# The North 60

Hospital Road, Nilsson Drive, Stevens Avenue, Old Saw Mill River Road  
Town of Mount Pleasant, Westchester County, New York

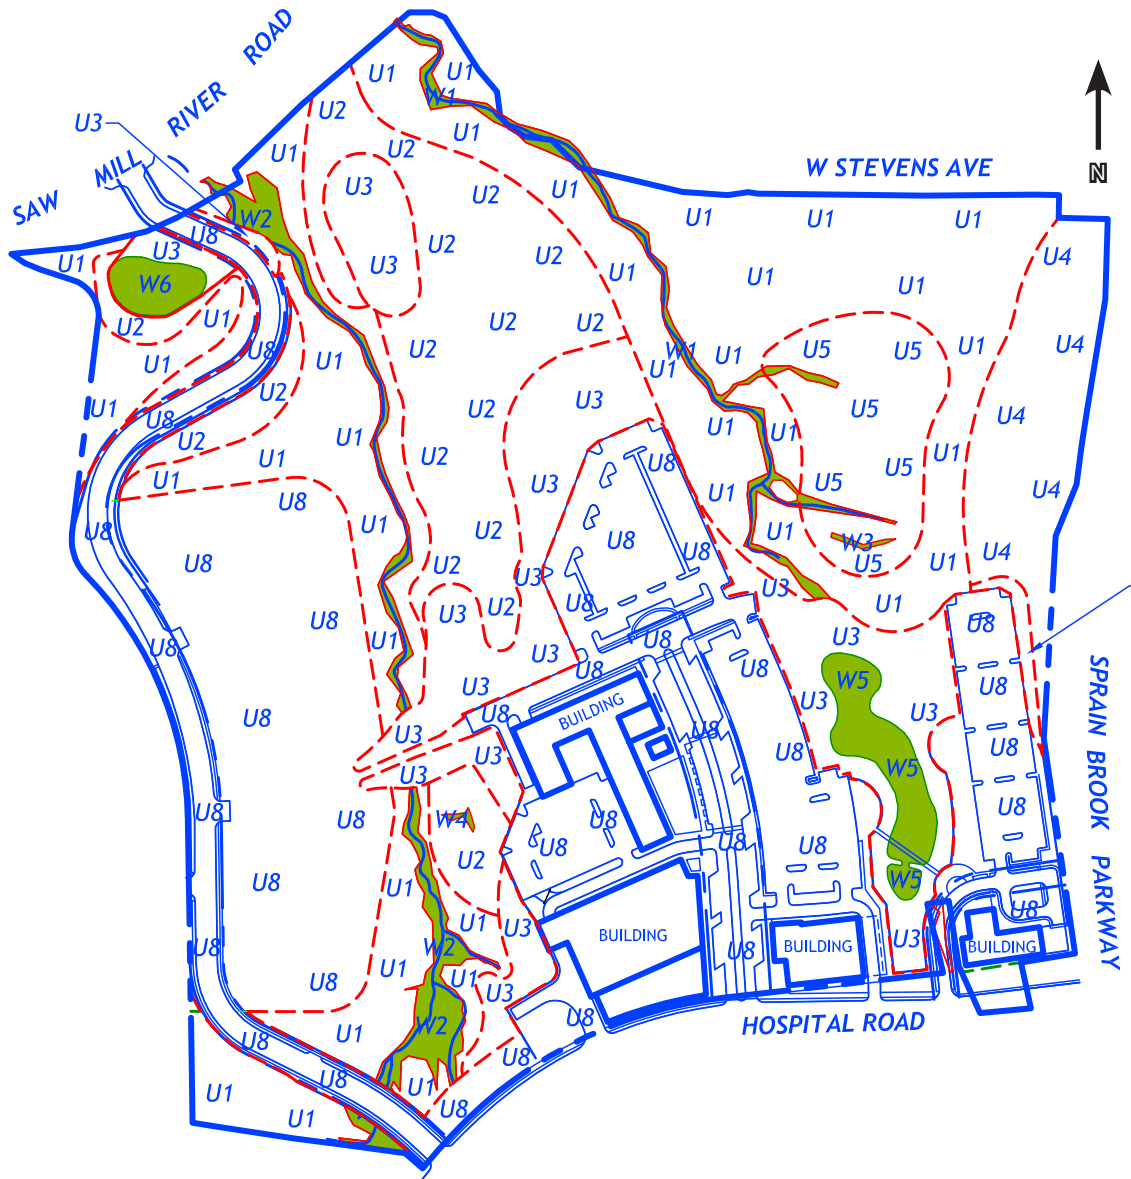
Chapter 201, Tree Preservation, of the town code identifies activities required for development applications. Pursuant to §201-11 of the code, a tree protection, preservation and reforestation plan are required for applications. As per the code, the Proposed Action would incorporate tree protection standards for remaining trees and would follow the standards to create a reforestation plan (see Mitigation section below). These plans include calculations to determine existing tree density, proposed tree density and considers tree species type, in order to create a mature forest canopy that would establish in proposed forest areas. Following the review of the Proposed Action and during the Site Development Plan review by the Planning Board, an application for development, in compliance with the tree preservation standards, would be filed with the Town.
